Product Change Notification / SYST-01SUTS663

ERRATA - PIC18F27/47/57Q84 Silicon Errata and Data Sheet Clarifications

Description of Change: Added silicon issue 1.1.5 to UTMR module as well as new errata 1.2.1-1.10.1 . Added new errata entry to UTMR module. Added data sheet clarifications 2.2, 2.3, 2.4, and 2.5.

PIC18F27/47/57Q84 Silicon Errata and Data Sheet Clarifications

1.6.1 UART TXDE Signal May Go Low Before the STOP Bit Has Been Entirely Transmitted

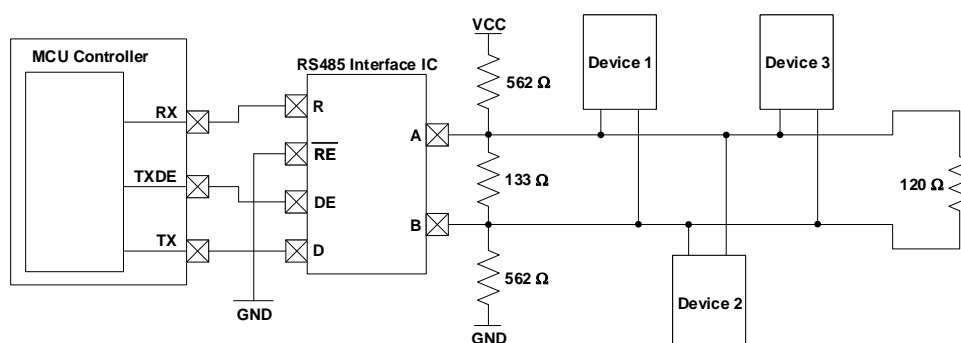
The UART Transmit Drive Enable (TXDE) signal could potentially transition into a low state before the UART STOP bit has been entirely transmitted due to the effects of parasitic capacitance on the TX line. In some applications, this could result in communication being prematurely terminated due to the TXDE bit going low before the STOP bit has had enough time to settle.

To ensure that the STOP bit settles into its final logic state before the TXDE signal transitions low, a biasing circuit can be implemented. A biasing circuit allows the TX line to either be driven high or low, rather than being left in a floating tri-state mode where prolonged rise or fall times could lead to communication being disrupted. This bias circuit should only be implemented on one end of the serial bus, and a termination resistor should be used on the other end. The figure below show an example of a bias circuit that can be used to achieve this.

Please note that the resistor values used in this circuit are recommendations, and that the actual resistor values required may vary based on the application.
